Fingerboards Mineral Sand Project

Inquiry and Advisory Committee (IAC) Panel Hearing

Groundwater

Assoc Prof John Webb

Fig 2.41 A006B

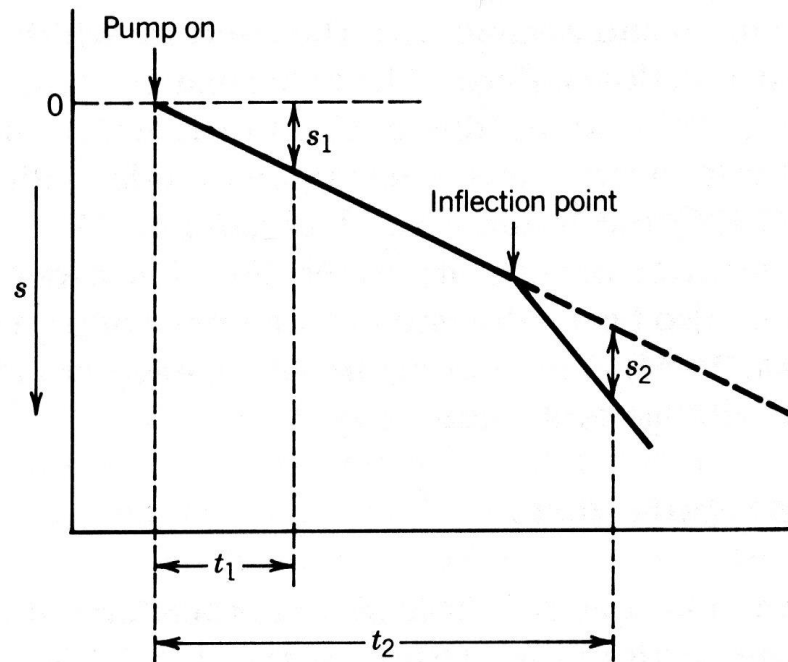
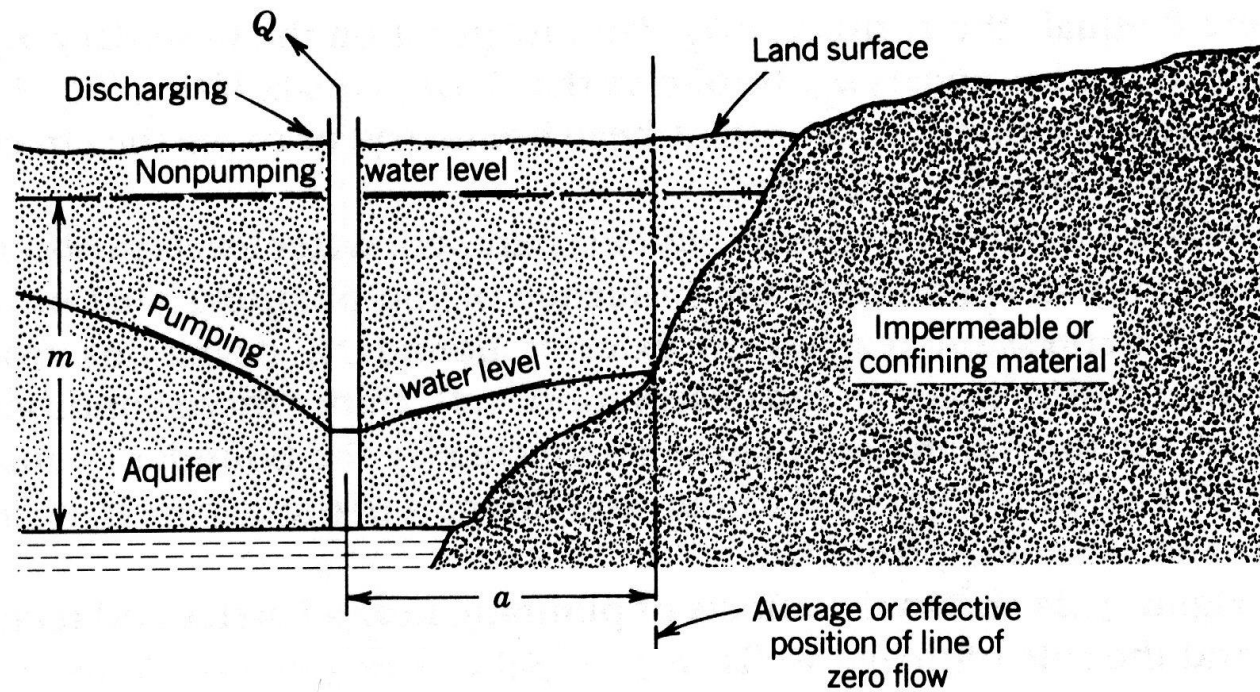
Late stage of pumping test for Fingerboards Project showed increased drawdown

Increased drawdown can be due to a nearby impermeable boundary

The distance to the impermeable boundary can be estimated from the time-drawdown plot

- Could be due to
 - Impermeable boundary – possibly nearby basement high
 - Lower permeability section within the gravel
- Gravels deposited by river channels often vary in thickness and permeability
- From the time-drawdown plot, the impermeable boundary/lower permeability gravel is ~60 m from the pumping bore – this calculation is approximate

Fig 2.48 A006B

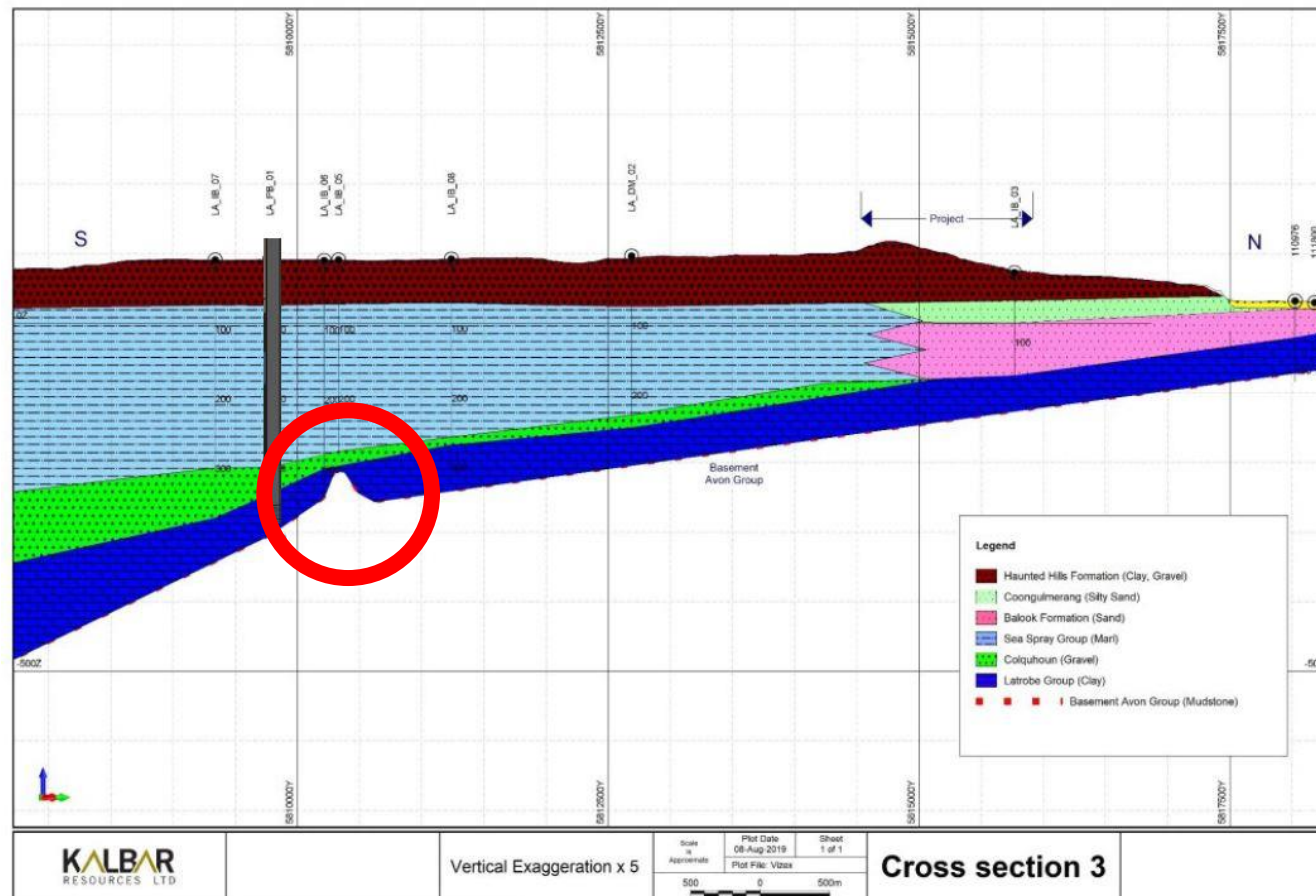
- Late stage drawdown could also be due to interference from nearby pumping bore within the same aquifer (drawdown cones are summed where they intersect to determine overall drawdown)

Fig 3.6 A006B

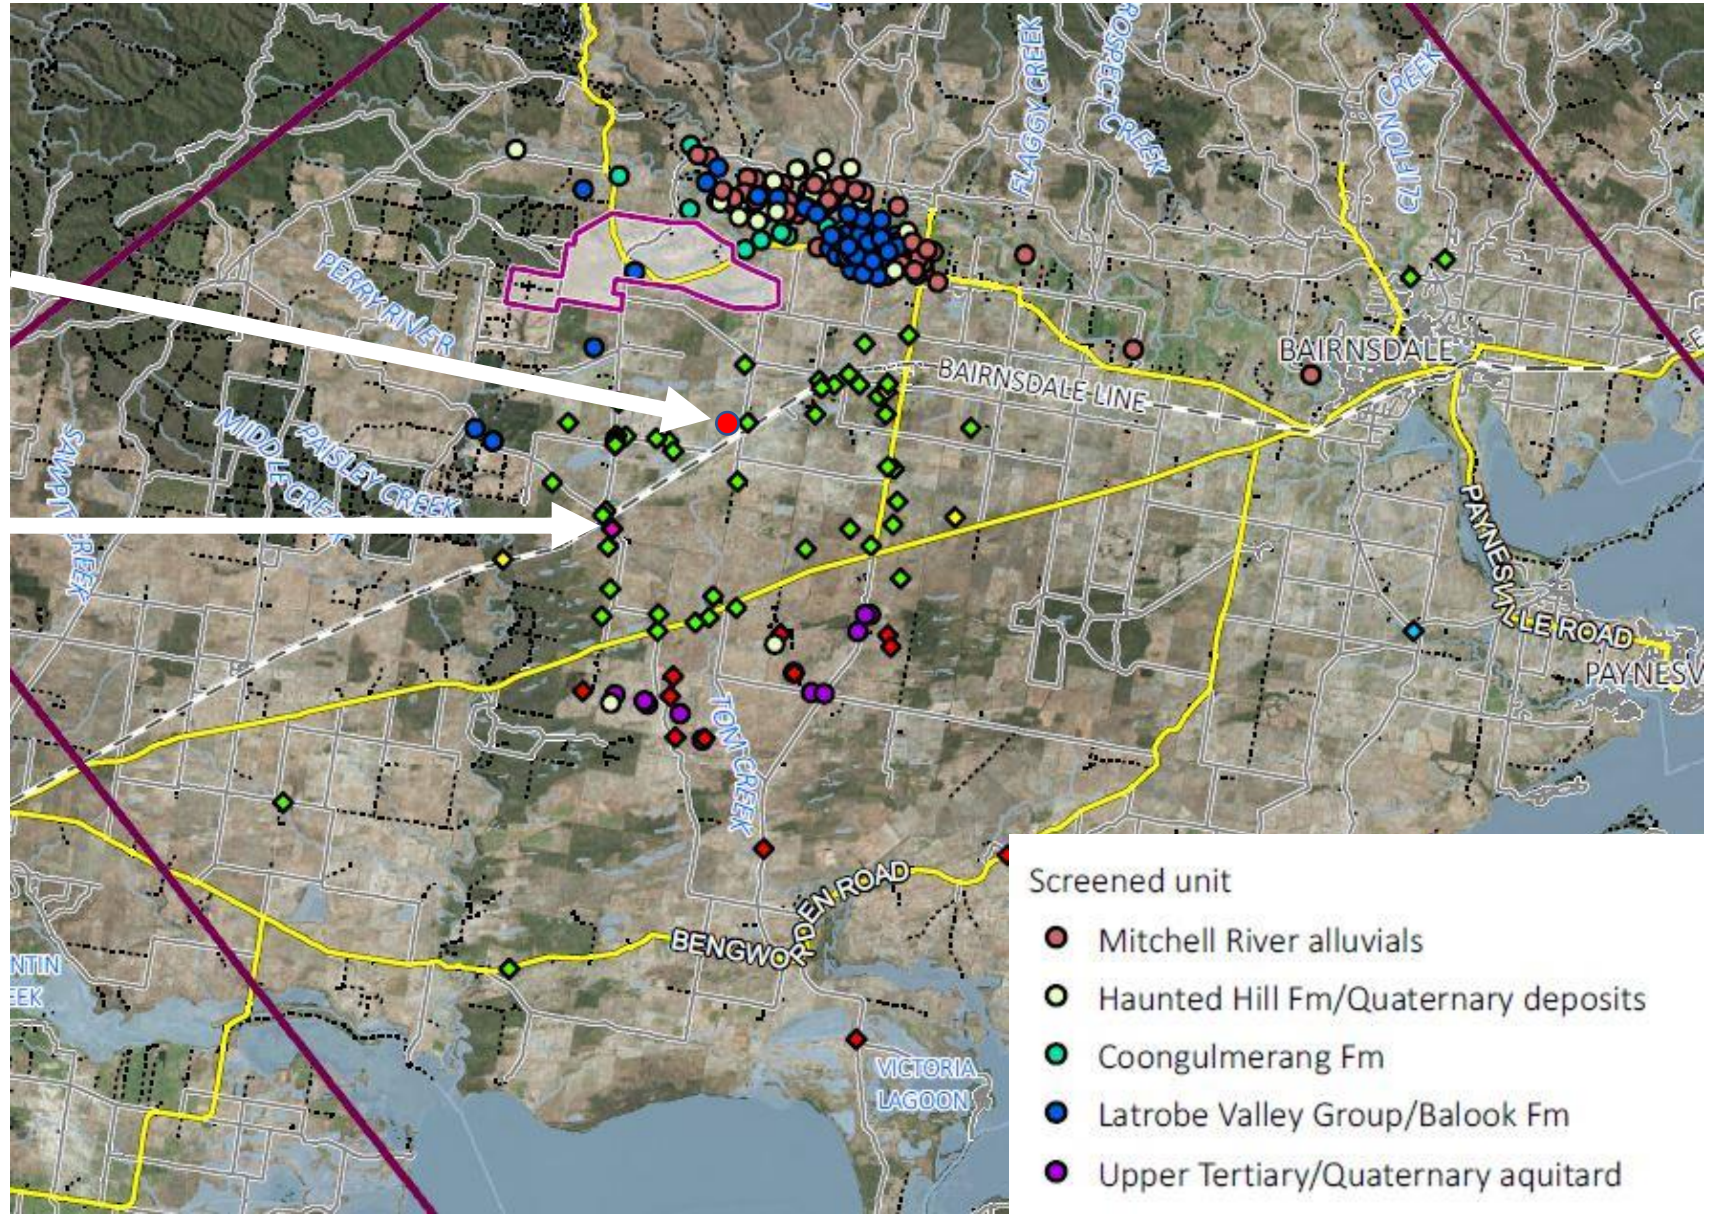
However, nearest bore in Latrobe Group to pumping bore is ~4.5 km away

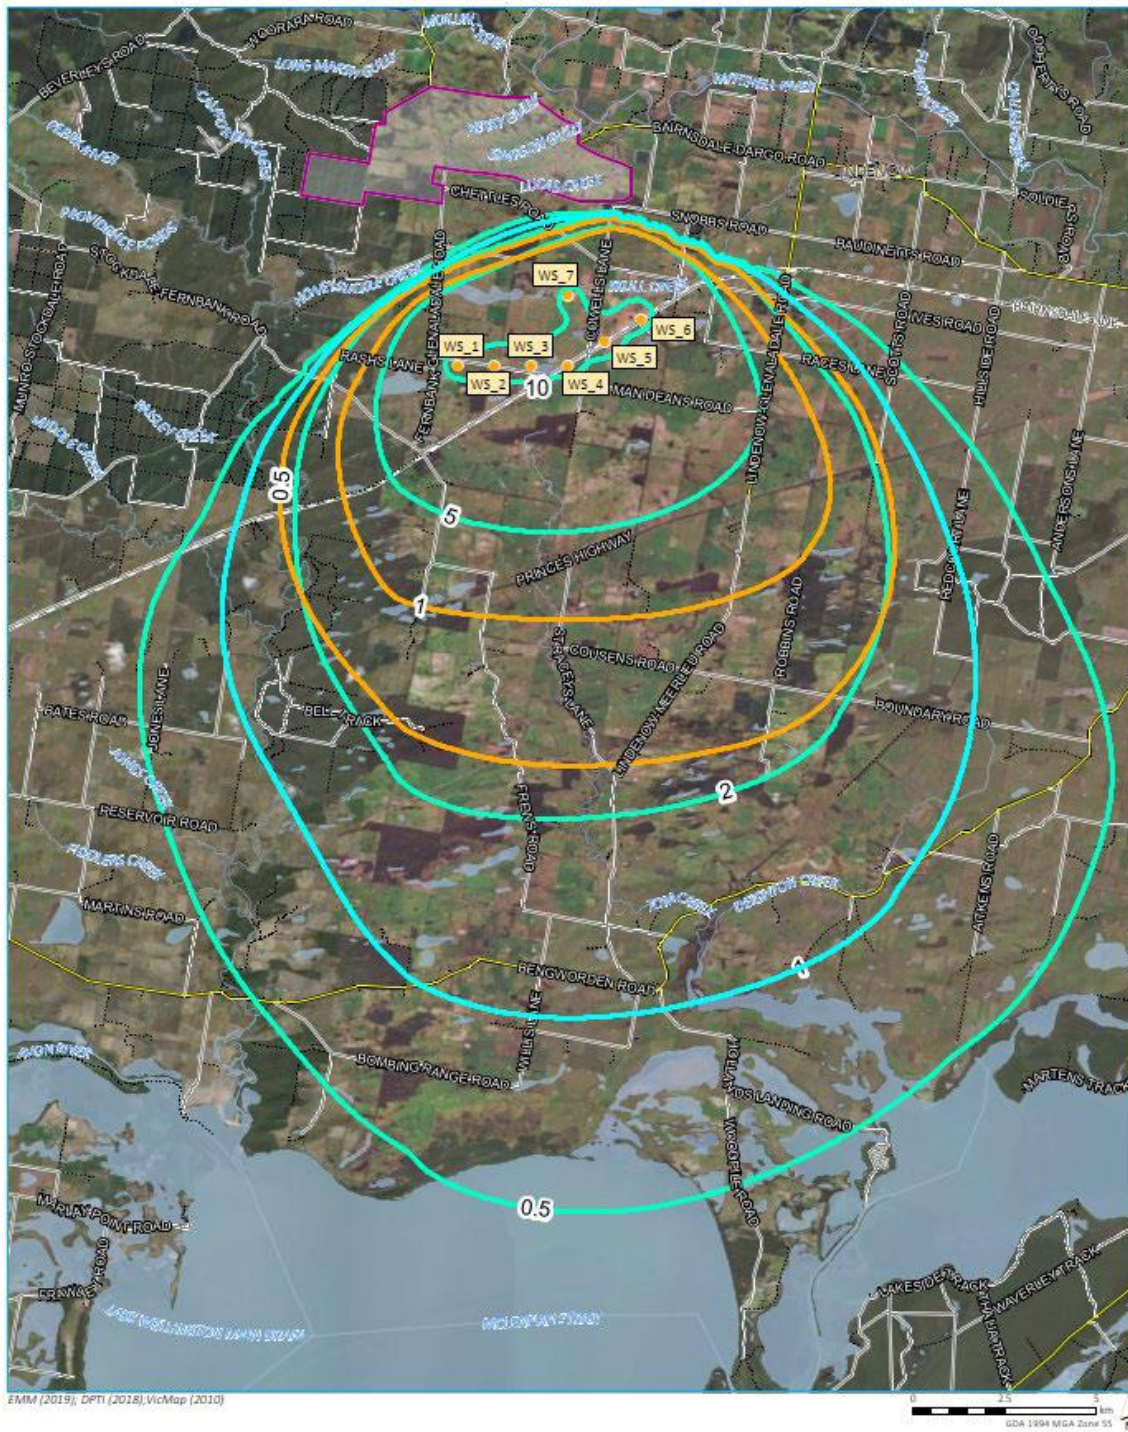
- The aquifer may be less extensive than initially visualised
- Drawdown around basement highs and/or less permeable areas will be greater than currently modelled
- Already the borefield has been extended from its original location and it is acknowledged that the rate of pumping from the bores may be less than originally envisaged

Current modelling does not take any of these factors into account – shows symmetrical drawdown around borefield

The planned additional pumping test should provide the necessary data to determine what is causing the late stage drawdown in the previous test.

Fig 6, Part A Submissions on behalf of Kalbar Operations Pty Ltd

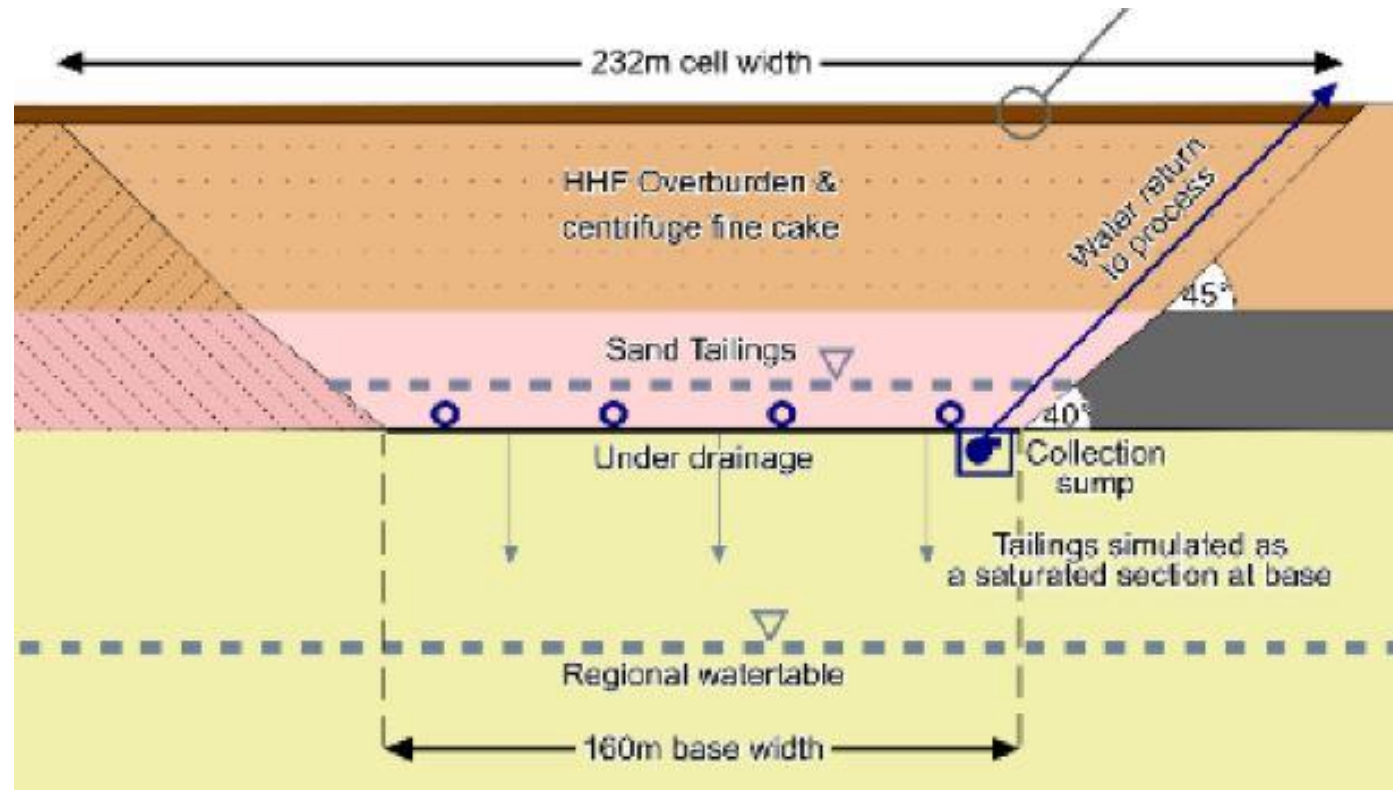
- However, the description of the proposed mining operation states that “All mining is proposed to occur above the water table” (Part A Submissions on behalf of Kalbar Operations Pty Ltd)
- The diagram of the proposed mining process does not show the installation of a subsurface drainage system

Fig 6-1 A006

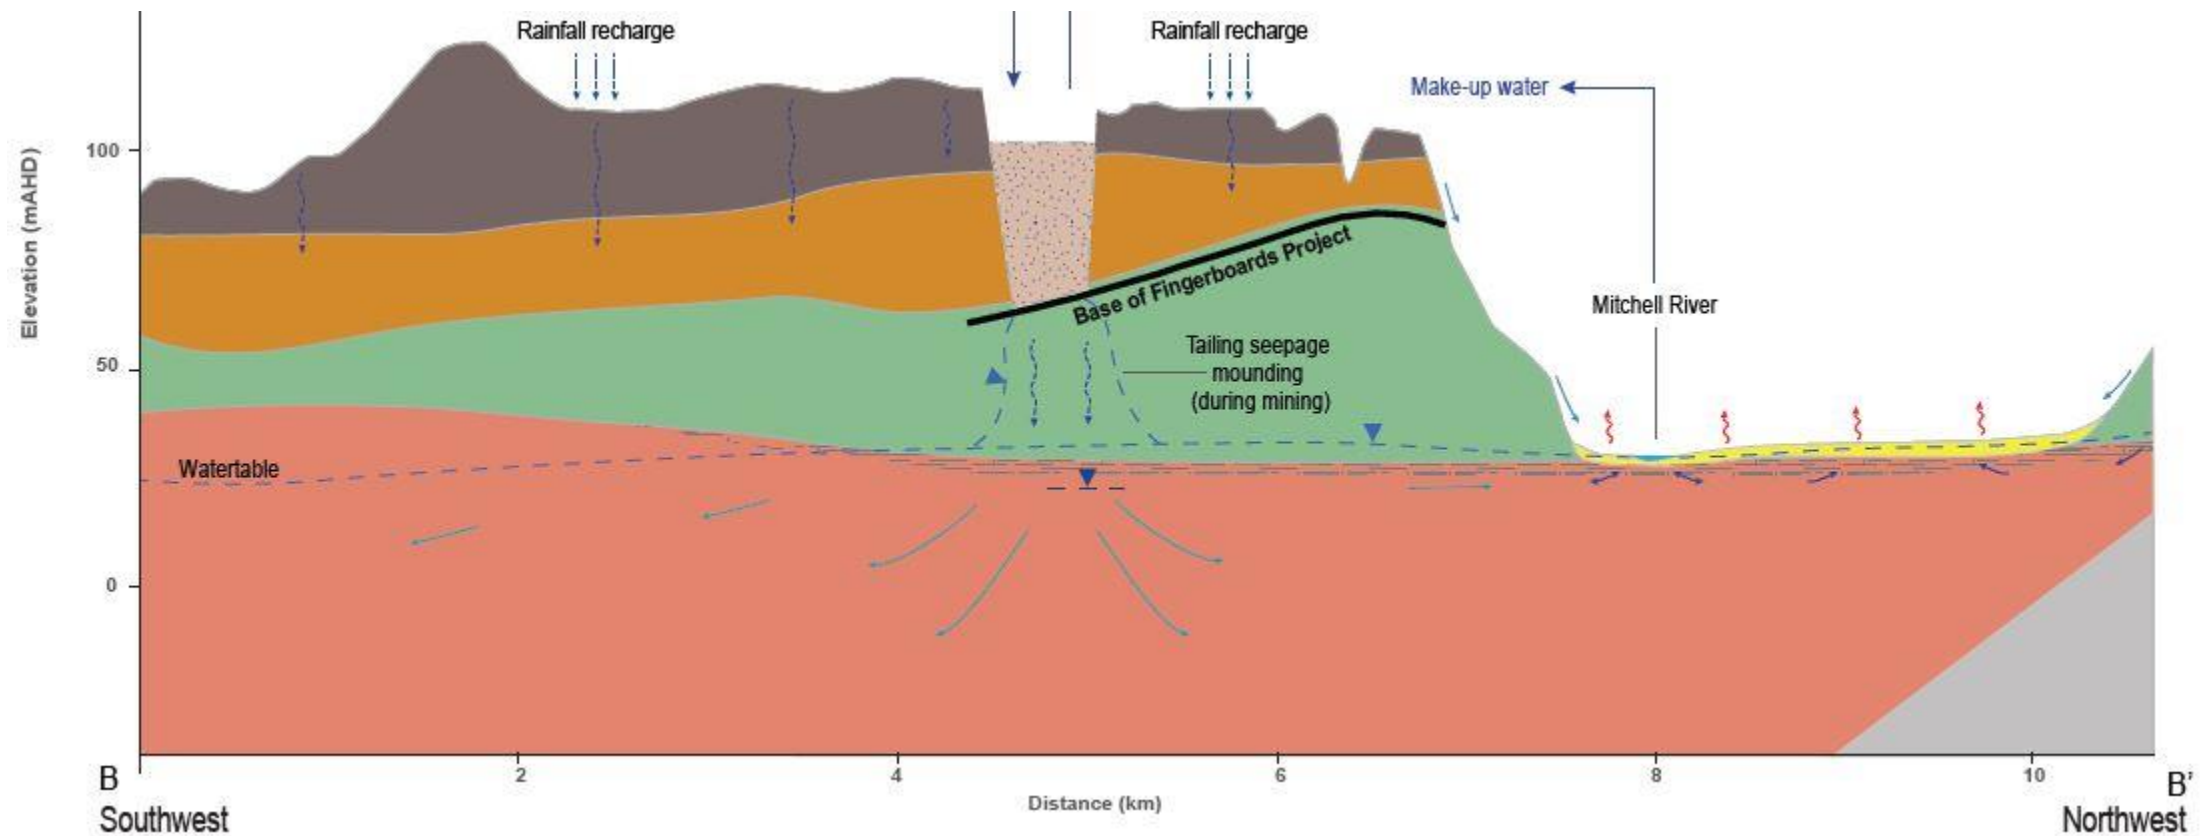
- The mineral sands of the Coongulmerang Formation were deposited in shallow marine conditions and most likely originally contained significant amounts of pyrite.
- Uplift of the area and incision of the Mitchell River has lowered the watertable and most of the pyrite originally present has been oxidised
